Memorandum

Re: 221 Danbury Rd
Proposed Day Care Center
Response to P&Z Commission Comments

**Proposed Re-Tenancing
and Playground for
Guidepost Montessori
Child Day Care Center**

221 Danbury Road
Wilton, Connecticut

Layout and Materials Plan

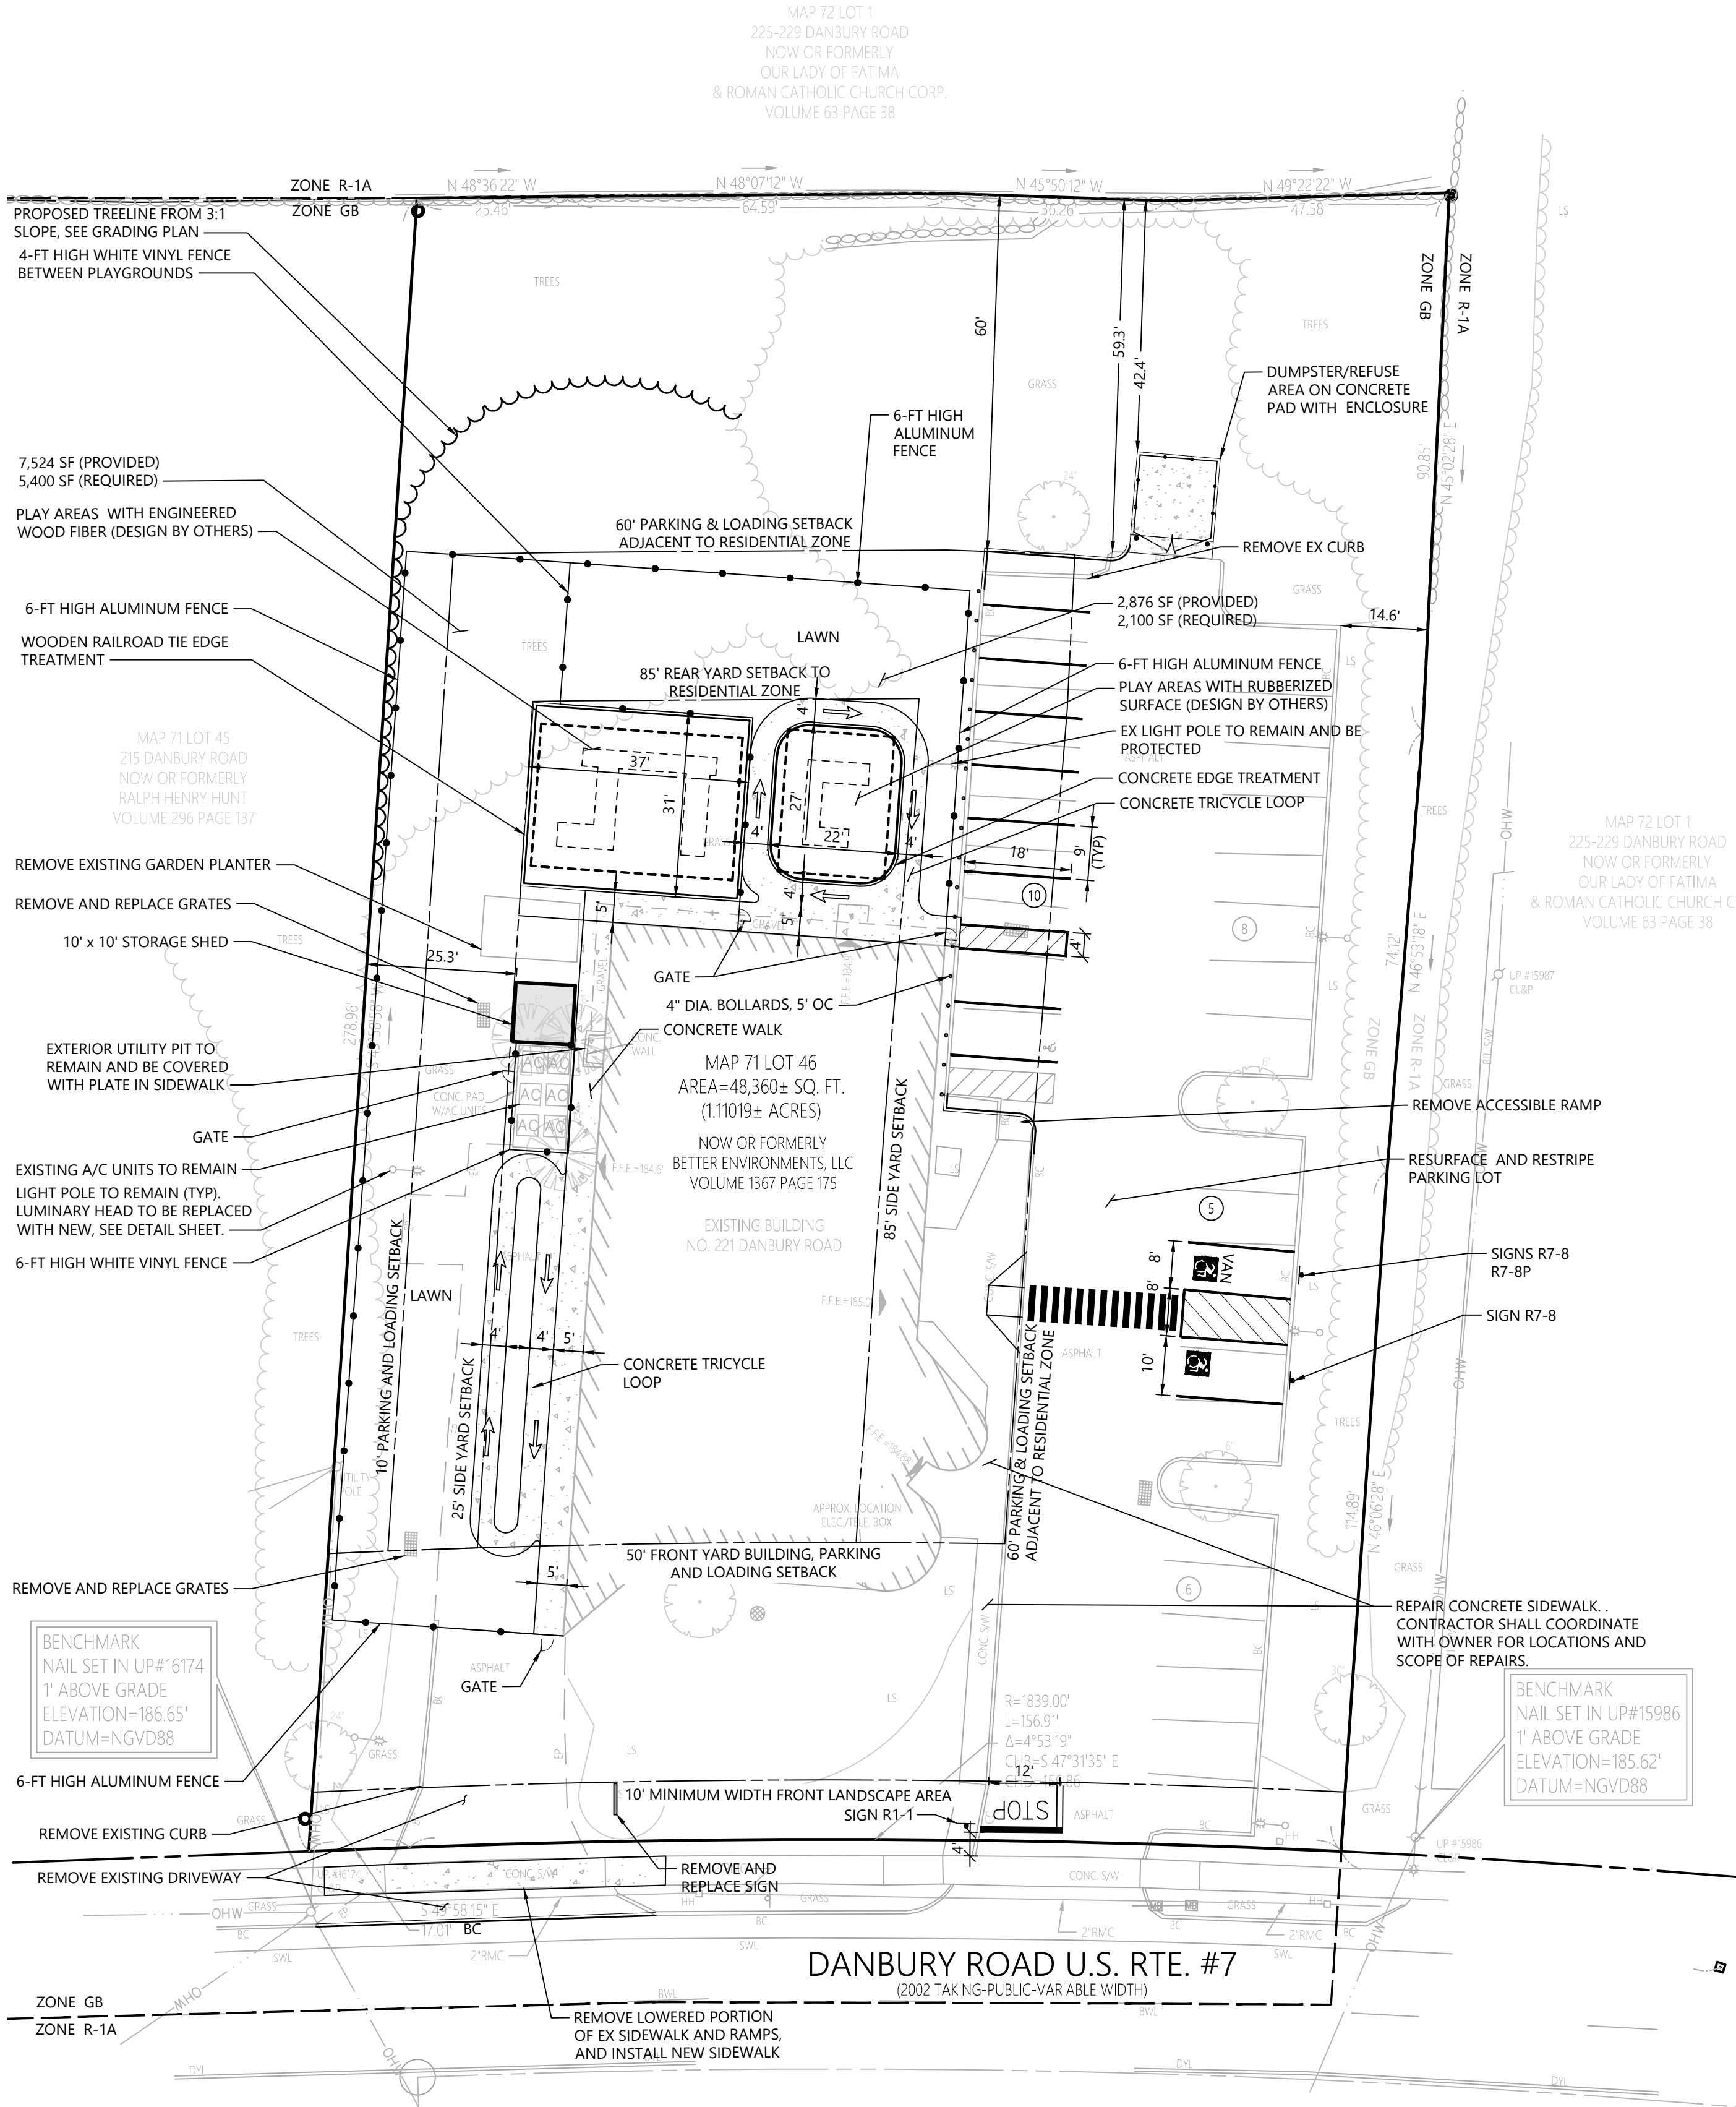
1. The existing parking lot striping has been modified as follows:
 - a. A 4ft wide striped path has been added directly in front of the access gate to the playground.

- b. The ADA spaces were moved to directly in front of the main entrance. The ADA spaces had to move because they could not fit appropriately when a 4ft path is introduced by the playground gate.

2. Bollards are added where the parking spaces are adjacent to the building and playground.
3. Landscaping has been added in front of the south playground area.

Drawing Title
Landscaping Plan

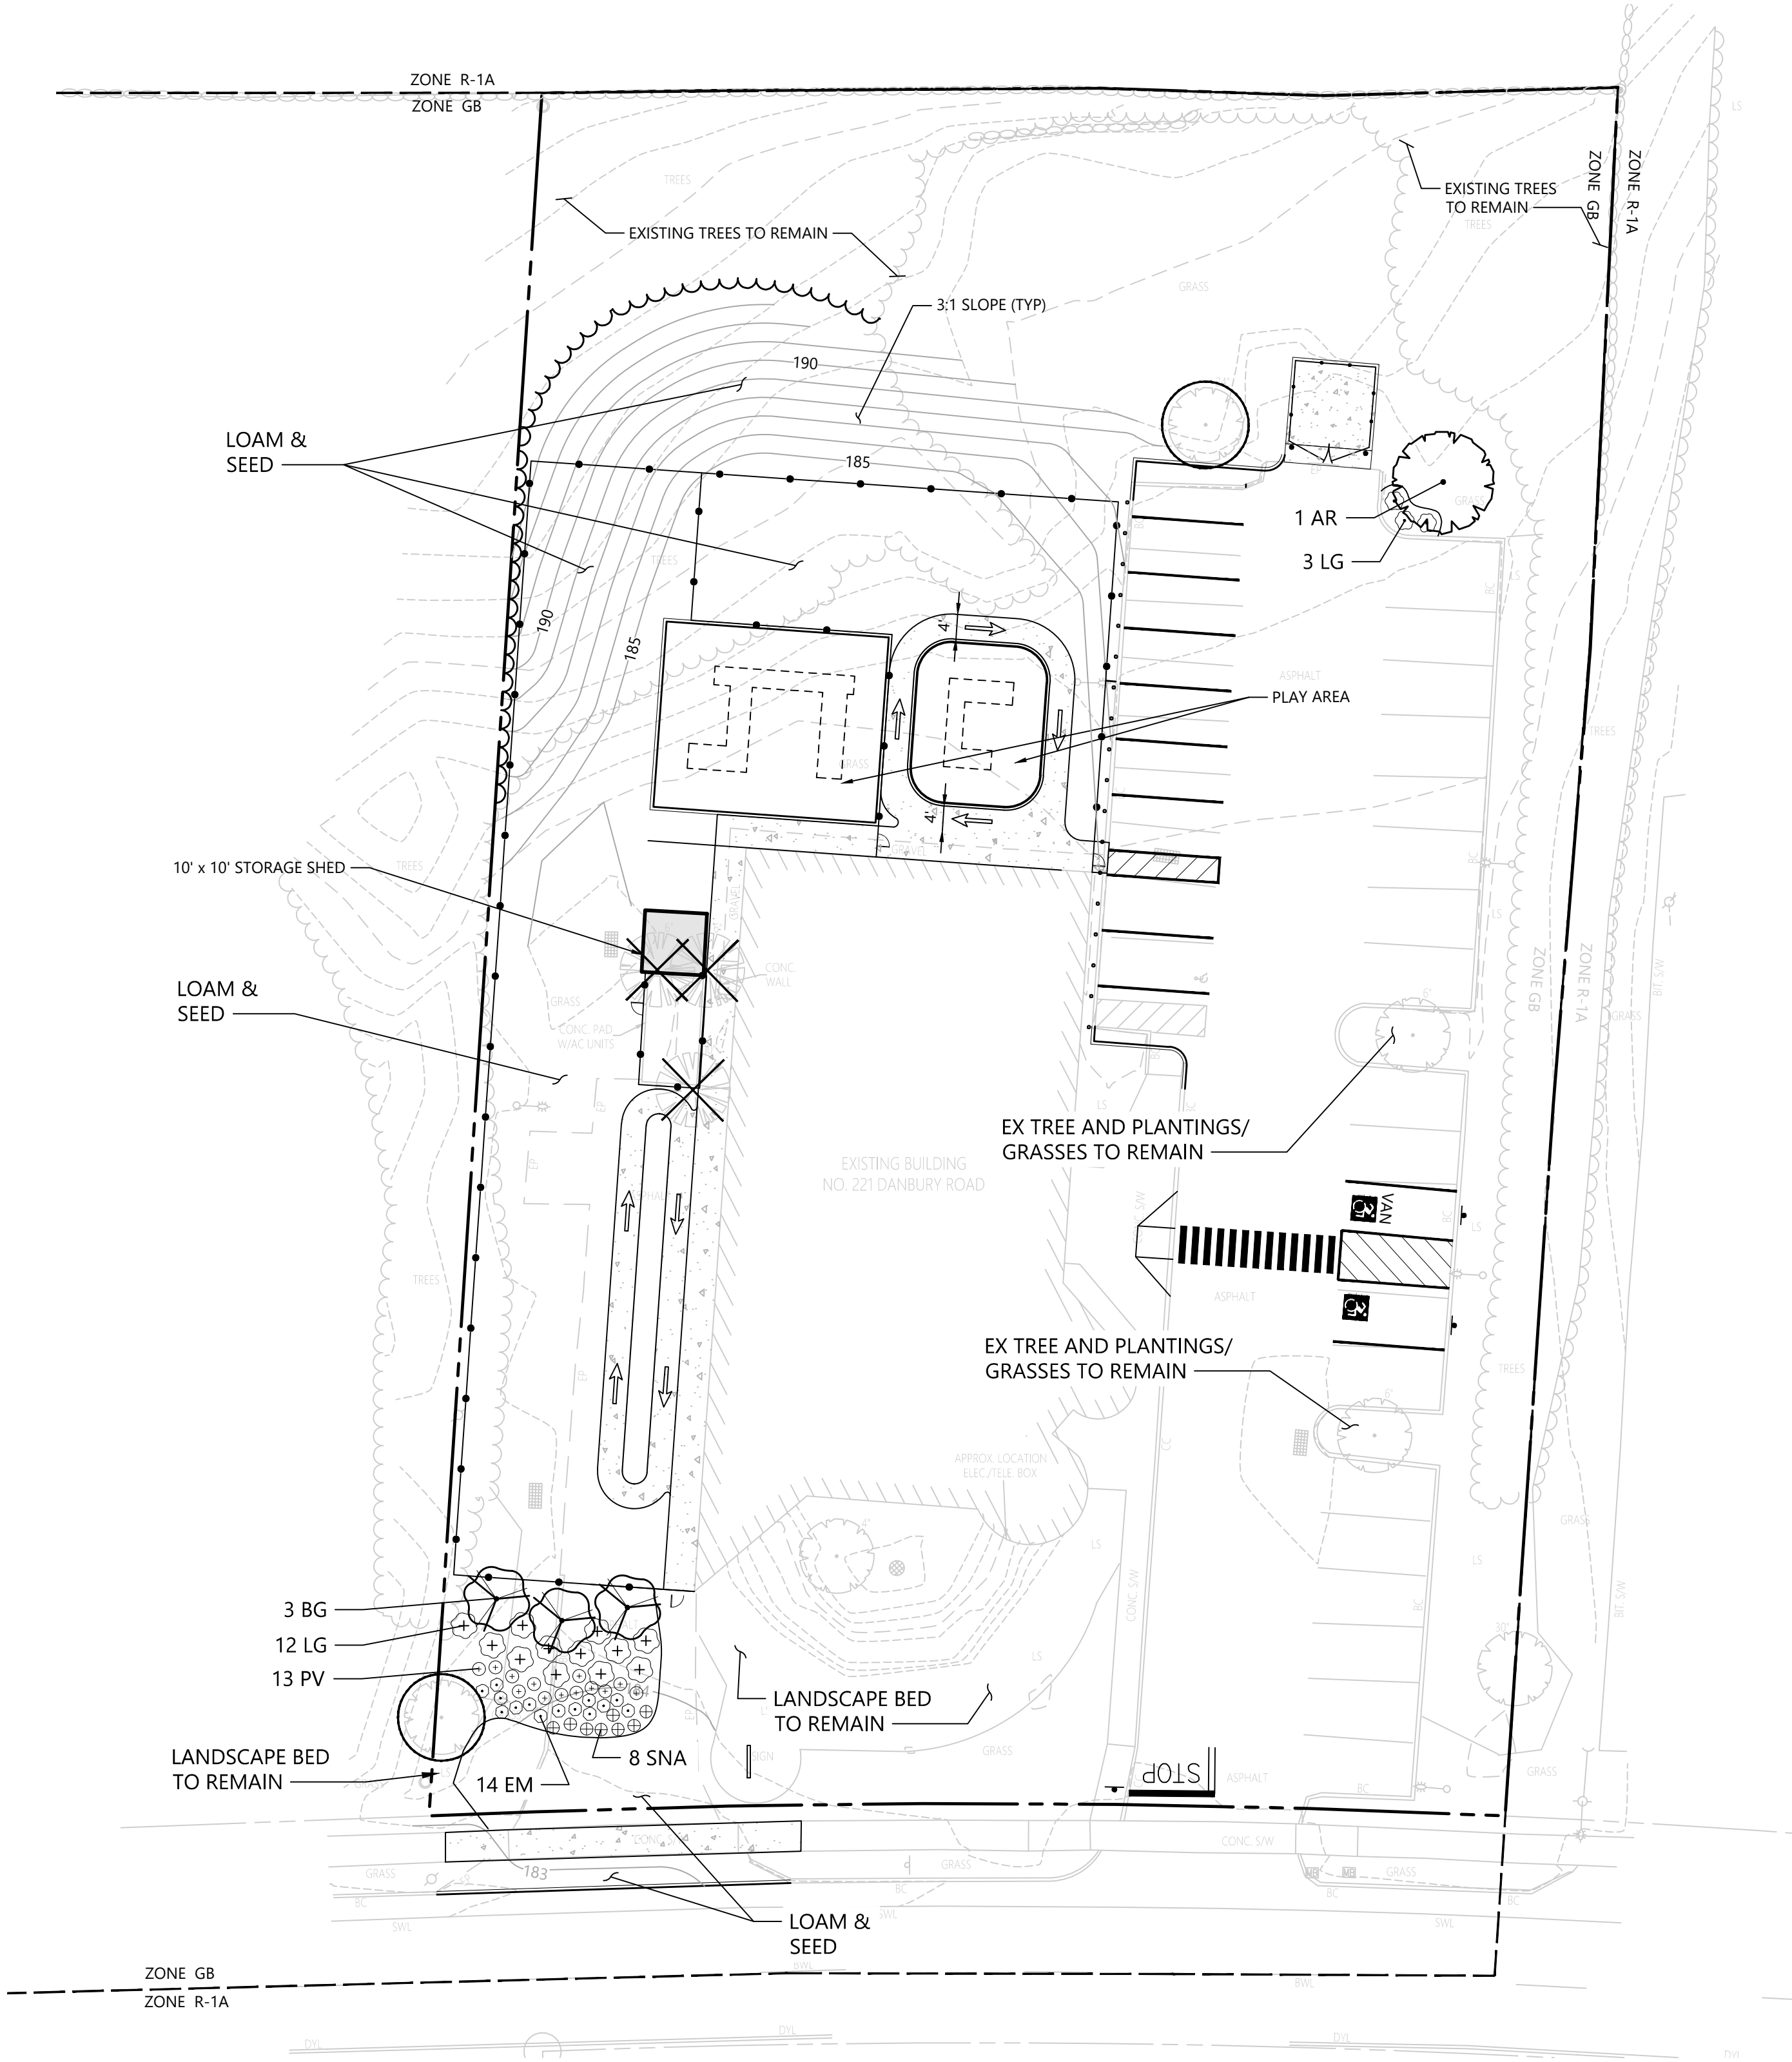
- a. Joe-Pye-Weed and Asters are main pollinators.
 - b. All plants are native to that area of New England
4. Attached is a spec sheet for the anticipated storage shed for the playground equipment.

- a. Note the shed is set back approx. 150ft from the Danbury Rd curb line.
 - b. The shed's sight line will be adequately screened by the building to the north, the existing vegetation along the south property line, and the new landscaping proposed in front of the playground.
